REVISED RESPONSE TO REQUEST FOR ADDITIONAL INFORMATION

APR1400 Design Certification

Docket No. 52-046

RAI No.: 520-8693
SRP Section: 06.02.02 - Containment Heat Removal Systems
Application Section:
Date of RAI Issue: 09/13/2016

Figure 1

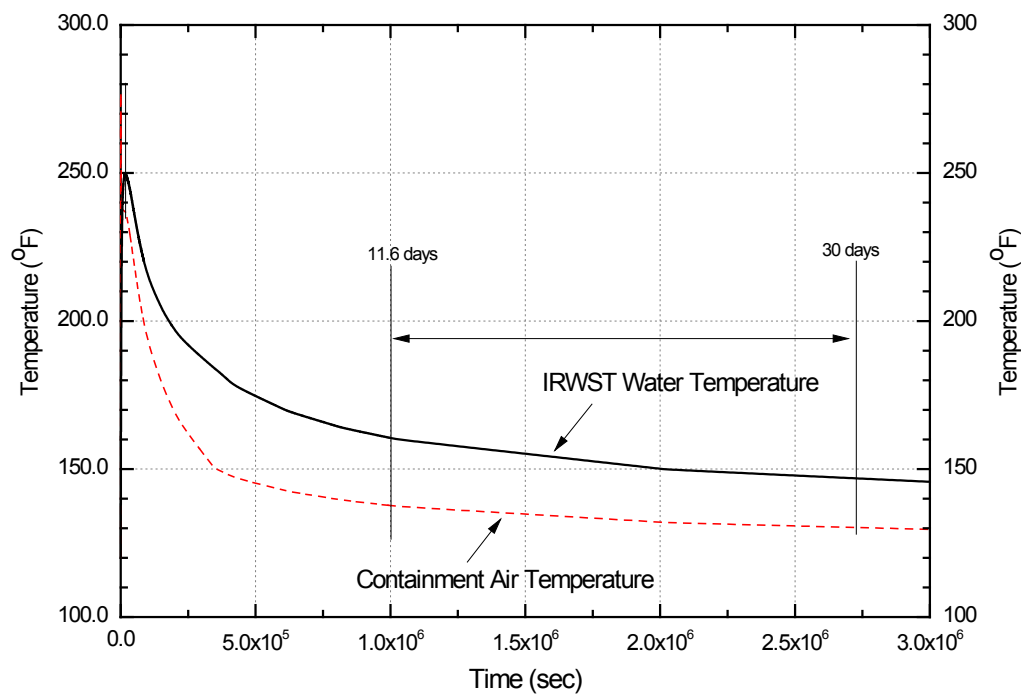
- a) description of how the sump and containment temperature profiles in FSAR Figure 6.2.1-4 were extended from 10^6 seconds to 30 days,
- b) a description of how the extension of the temperature profiles was documented, and
- c) the 30-day sump and containment temperature profiles used in the chemical precipitate calculations.

The containment and sump temperature profiles, which were produced from the limiting LOCA that yields the maximum containment pressure, had been used for calculating the chemical effect until the DCD Rev. 1. However, The LOCA containment analysis that yields the highest sump temperature has some differences in the containment initial conditions from that applied to the containment model described in DCD Section 6.2.1 that maximizes the containment pressure. Thus, the containment responses to a LOCA were recalculated with the initial conditions that maximizes the sump temperature and its results has been finally chosen for the chemical effect analysis.

The description of the containment model that yields the highest sump temperature is presented in the Appendix B, Section B.4 of Technical report, APR1400-Z-A-NR-14007-P, "Mass and Energy Release Methodologies for LOCA and MSLB", Rev. 2. From the comparison of all LOCA analyses, the scenario that yields highest sump temperature is estimated to the case "Double-ended discharge leg slot break with Max. SI flow".

Figure 1 below illustrates the temperature profiles of the containment and sump extended up to 30 days of the accident.
